My objections on 24/00541/REM | Reserved matters submission (appearance, layout, landscaping and scale) pursuant to outline planning permission reference 19/00836/OUT for the construction of 265 dwellings | Land East of Eyebury Road Eye Peterborough

Screen shot of the proposed 'Rain Gardens not showing the private network of pipes Houses 120-138

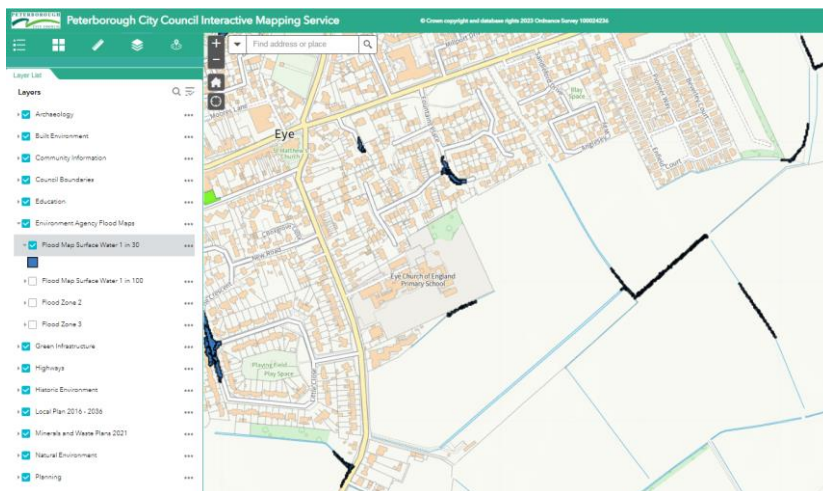
- There is no drainage shown for the Public Right of Way (PROW) Cycleway and footpath heading north from the site to Thorney Rd.
- Currently the dyke adjacent to the school playing fields does not go into the main IDB drain on the site and as such it floods during the winter, see attached copy of PCC Flood Map Surface water 1 in 30 and identified in Larkfleets Archaeological Assessment Mar 2018 below. This currently floods the school playing fields and the future houses around will also be water logged (house Numbers 120 to 138).

- The proposed solution is for 'Rain Gardens with a private network of pipes to join up with the piping to the SUD's, is it a PCC approved method, Is it suitable for this flat land, its soil substrate and water table?

- The pipe work from the gardens to the surface water drainage system is not shown on the PROPOSED DRAINAGE STRATEGY SHEETS - 2 EYE-PPC-00-XX-DR-C-0221 and EYE-PPC-00-XX-DR-C-0222. There are the same Issues around the North of the site that are also marked with this rain garden approach at 147-157, 198-203, 212-216, 226-236. In all a total of 49 Households.

- The proposed rain gardens are not shown on any of the 7 Landscape Proposals detailed plans GLY0054 LP01 to 7

Plate 7: The west end of the west field, looking SW from the corner of the school grounds across the flooding boundary drain.

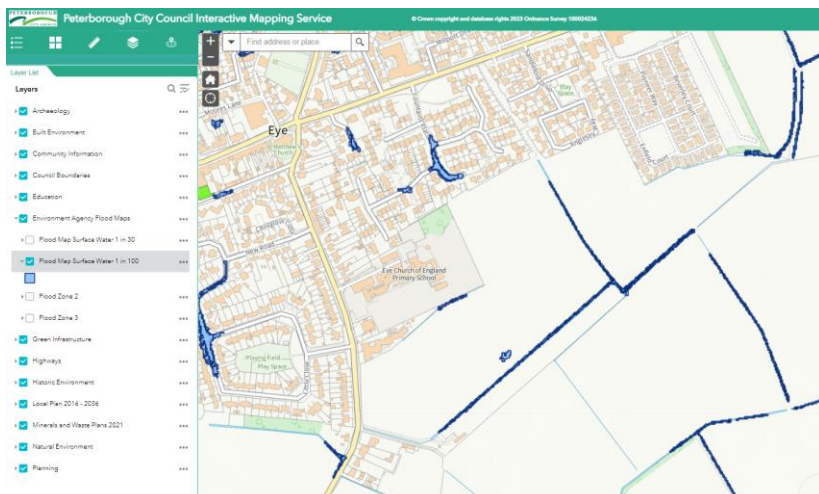
The north-west corner of the site is formed by the incursion of the village school and its grounds into what was formerly part of the field. The school is divided from the site by a chain-link fence and a high hedge; all the existing school buildings appear to be mid-20th-century or later in date. A drain starts at the south-east corner of the school site and runs westwards towards Eyebury Road: the drain was flooded and overflowing at the time of the site visit, barring access to the west end of the plot (plate 7).

PCC Flood Map Surface water 1 in 100

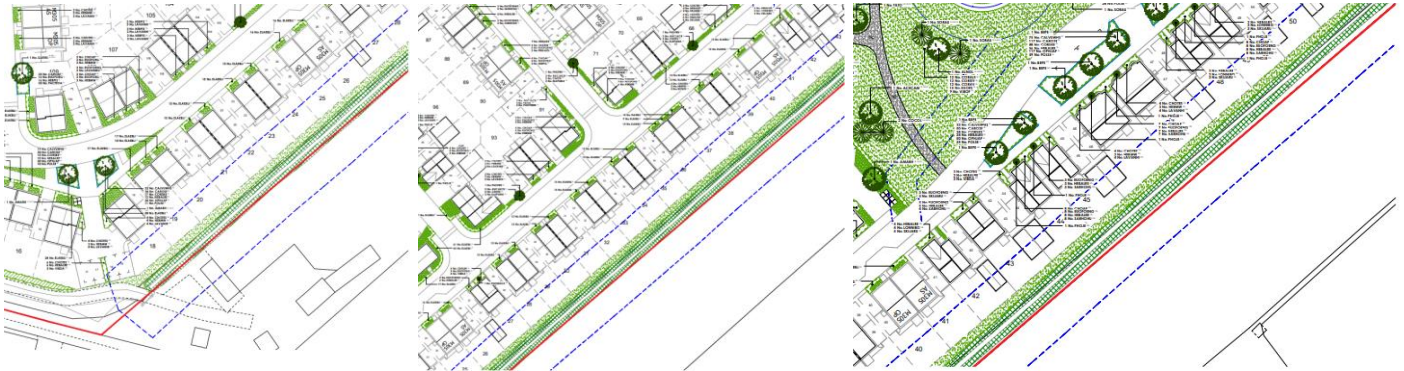
- The other dykes around the boundary with Fountains place and Pioneer caravans are not included in the site layout diagrams.
- How and who will maintain all the dykes around the boundary with Fountains place and Pioneer caravans.
- The Dykes to the South and East of the site are also shown as subject to surface level flooding, as these are IDB drains and currently flood on the South boundary, what agreement has been made to ensure access and future maintenance as now there will be households at risk not just farmland ?
- The Connectivity plan does not show how the Internal Drainage Board will get access to the North - South main drain and the Southern dykes for maintenance.
- See below the area around the site that show surface flooding on the PCC Interactive map for 1 in 30 and 1 in 100 years.

Flood Risk Assessment by Patrick Parsons dated Aug 2023 Section 8.0 Foul Water Drainage Strategy

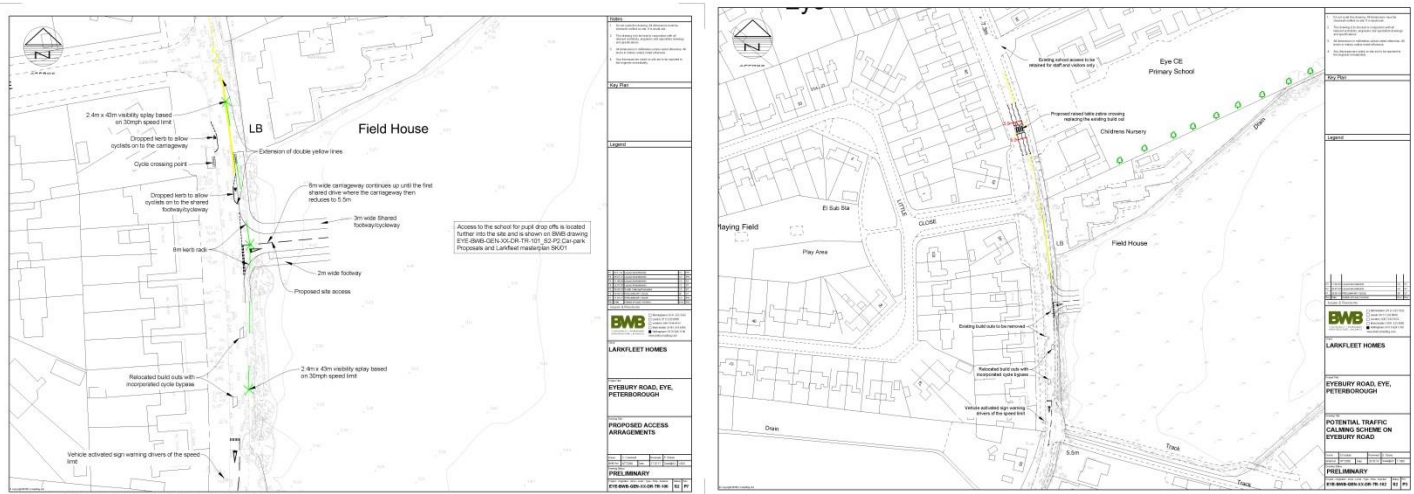
The latest Flood Risk Assessment by Patrick Parsons dated Aug 2023 section 8 states the foul water should be sent via Thorney Rd, (pasted below), however the application shows the connection to be on Eyebury road which has already documented capacity Issues therefor there is no documented agreement, plan and timescales to ensure the works required by Anglian Water can be achieved

- Anglian Water's public sewer records show that existing foul sewers serving Eye to the north of the development run collect at a pumping station in Fountain's Place adjacent to the development boundary with a rising main running northwards. It is proposed that the development discharges foul water to this pumping station. A gravity connection is likely to be unachievable so one or more pumping stations will likely be required

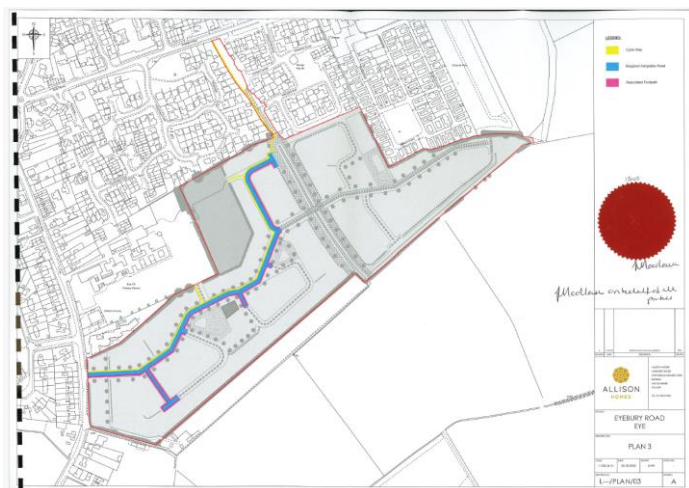
10 - I object to this application because of not enough visitor parking spaces Condition C28
Parking Plan L195/PARKING/01 only shows 40 visitor parking spaces and 4 Allotment parking spaces, this will not be enough for a site of 265 houses especially in evenings, weekends and holidays

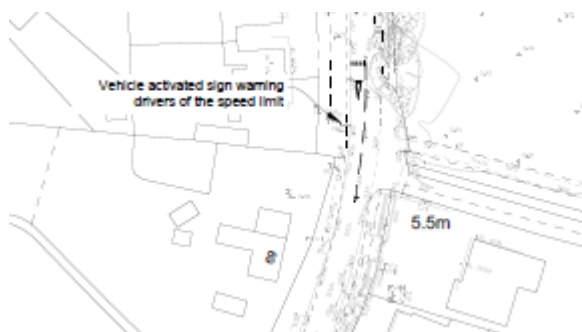
The Internal Drainage Board (IDB) at Outline Planning application requested the following, have they been done to IDB satisfaction?

1. If at all possible I would like to see the public footpath moved from the brink of my Boards Drain to between 6m and 9m back from the brink.
2. Can the proposed new cycleway on the northern end of the Boards Drain be moved to a minimum 6m away from the open watercourse. This is to prevent any possible damage being caused when our maintenance plant access the open watercourse.
3. In principle I agree to the piping of a short section of our Tanholt Drain at the northern end, however a formal application for consent to alter this watercourse will be required and I would like to see this conditioned to ensure agreement is reached before any work commences on site, as the details regarding this work are yet to be finalised.

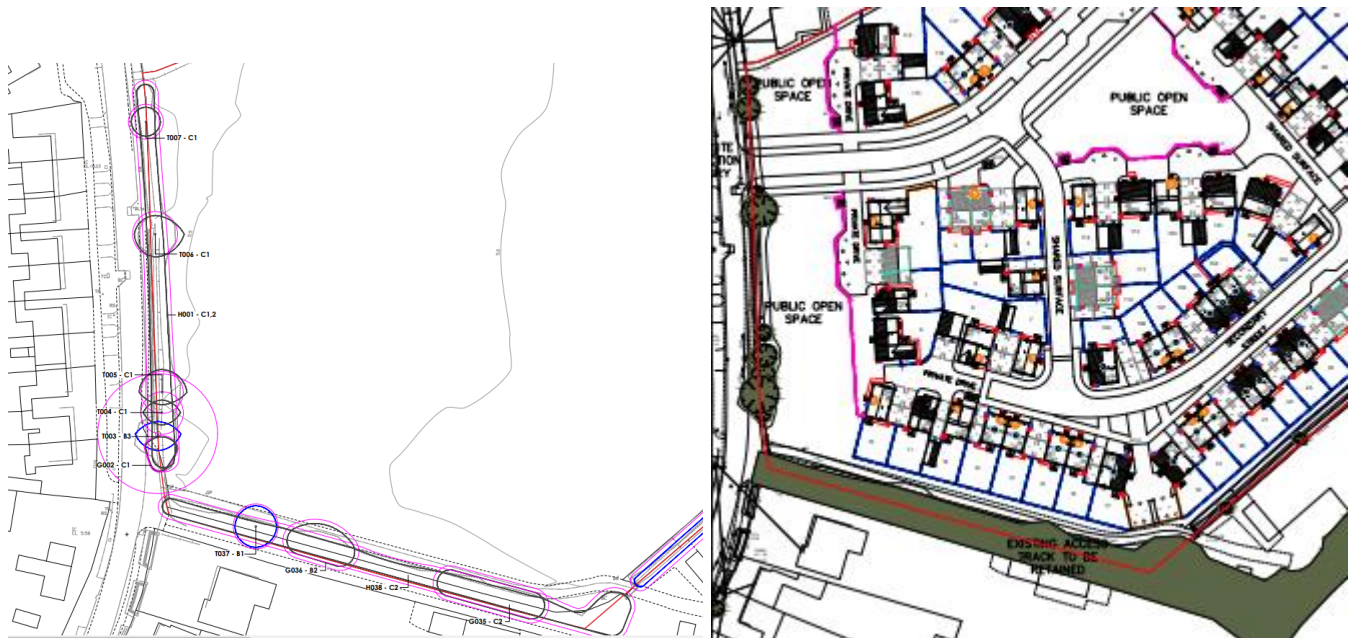
14 - I object to this application because it is not clear what the impact to the trees and hedge row on Eyebury Rd will be due to Condition C27 Vehicle to vehicle visibility splays measuring 2.4 metres measured along the centre line of the minor arm from the channel line of the major arm by 43 metres measured from the centre line of the minor arm along the channel line of the major arm in both directions shall be provided at the new junction on to Eyebury Road

- There is no document to show how this will be achieved and impact on the current hedgerow and trees, and various submitted plans still show the trees in place

2.2 To the west of the site, an existing hedgerow and sporadic ash and elm trees define the site boundary adjoining Eyebury Road. The hedgerow is in poor condition, with frequent gaps, considered to be low quality (category C). The trees are predominantly ash and elm, also of low quality. T003 is a more substantial elm. The tree was contained by dense vegetation, but appeared to have a substantial stem diameter, likely being an historic tree that has suffered failure or been substantially reduced in the past. It is identified as category B3.
